**SUBMISSION IN RESPONSE TO THE PROPOSED DEVELOPMENT  
DA 200704152  
BLOCK 1671, TUGGERANONG  
210MW GAS TURBINE POWER STATION AND DATA STORAGE CENTRE**

**Submission to the**  
**Preliminary Assessment of the Application for a**  
**Data Centre and a Power Station –**  
**Titled ACTEWAGL Canberra Technology City**  
**proposed for Tuggeranong Block 1671**

**Canberrans for Power Station Relocation Inc (CPR)**

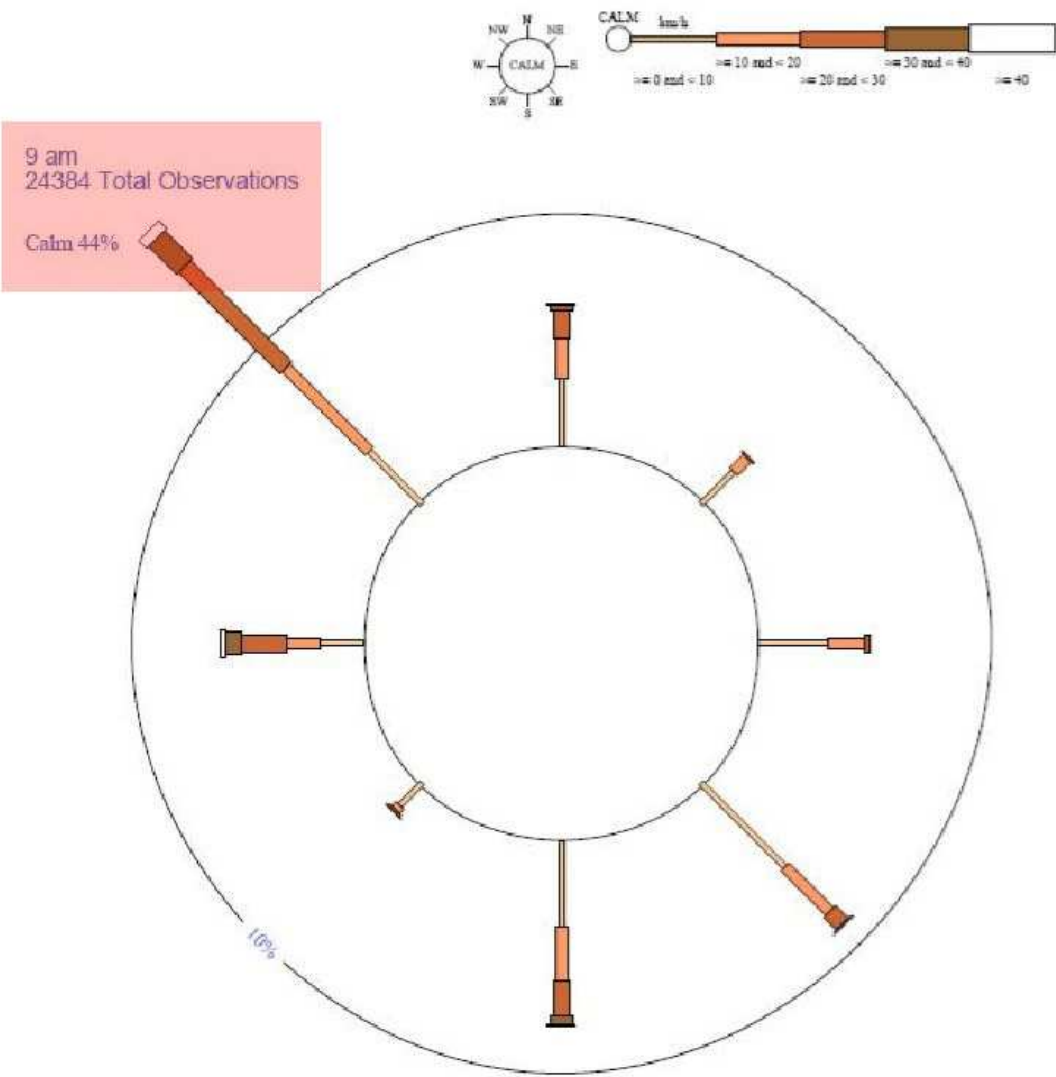
The proposed site is in an area of complex terrain. The site itself rises from 621 metres in the North to 641 metres to the South. It is located adjacent to the Mugga Lane Landfill Tip which has a substantial rise. In addition, over the hills to the West and South West is the Tuggeranong Valley and to the North West is a ridge, over which is the suburb of Isaacs, the majority of which is on sloping terrain.

There is a high frequency of calm conditions in Canberra. Therefore it would seem that in this case AUSPLUME V6 should not have been used to model the plume effects and therefore the assessment is invalid.

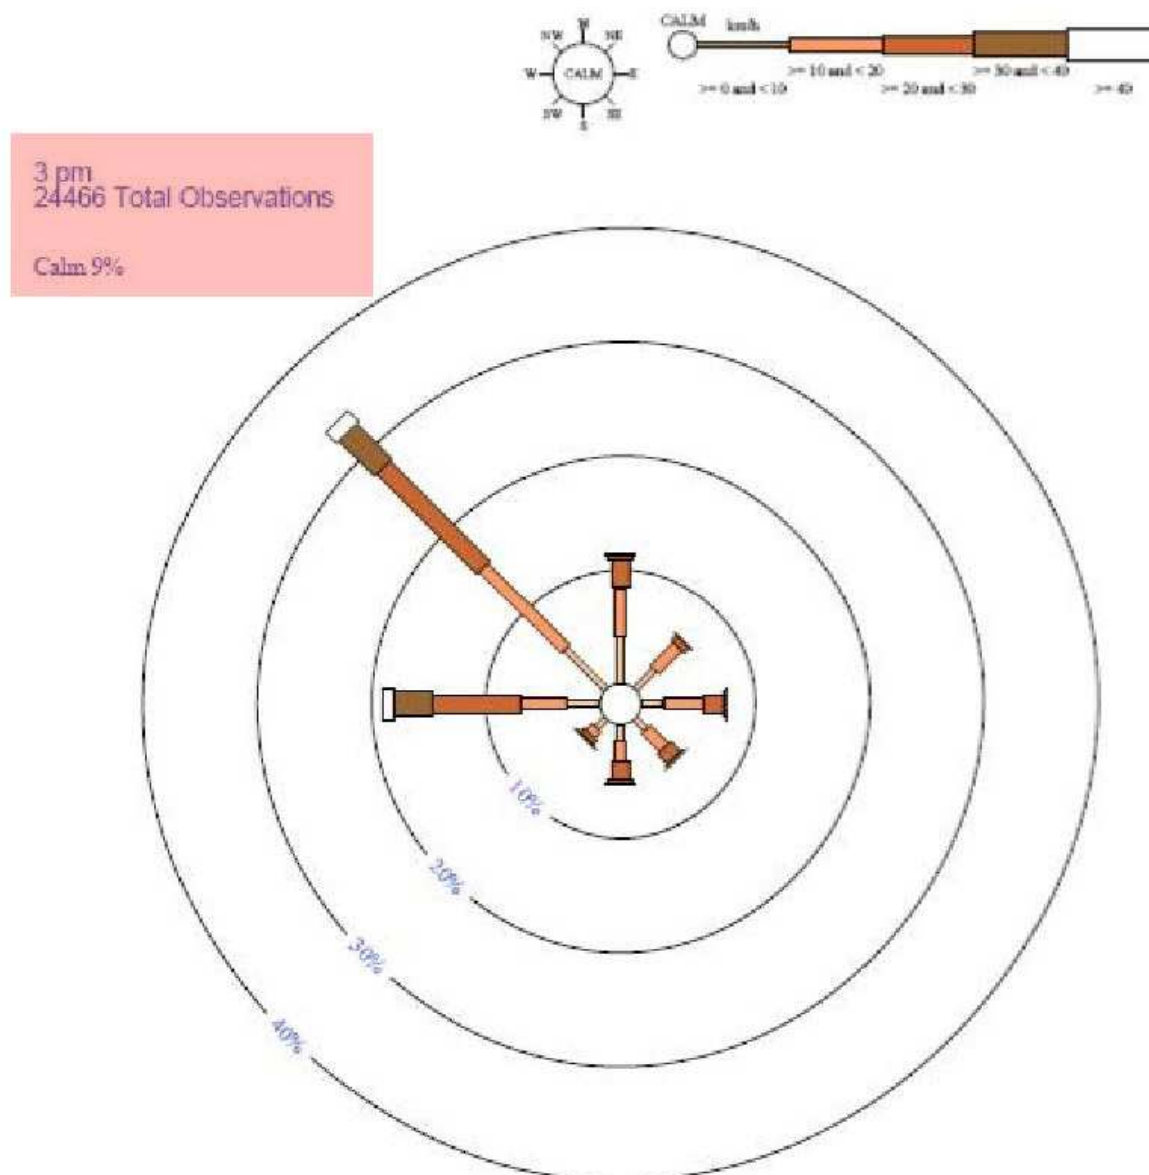
According to data from the Bureau of Meteorology (which is contained in the Acoustic Assessment from Bassett Engineering), it is:

**Calm 44% of the time at 9:00 AM**

**And calm 9% of the time at 3:00 PM**

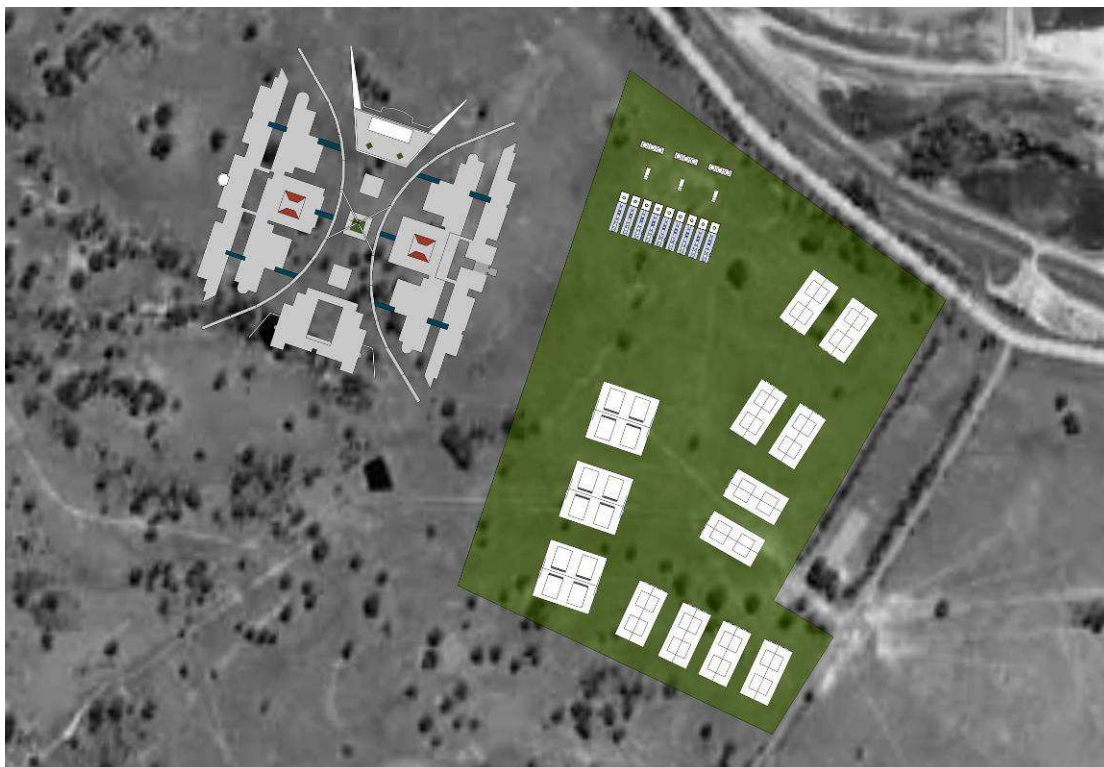
"They are just 12 small stacks" - Michael Costello, incoming CEO for ACTEWAGL on 666 ABC Radio 14<sup>th</sup> May 2008

The chemicals from each stack are pumped out at between 104 and 108 kilometres per hour at between 465 and 500 degrees Celsius. There are 18 stacks, not 12.
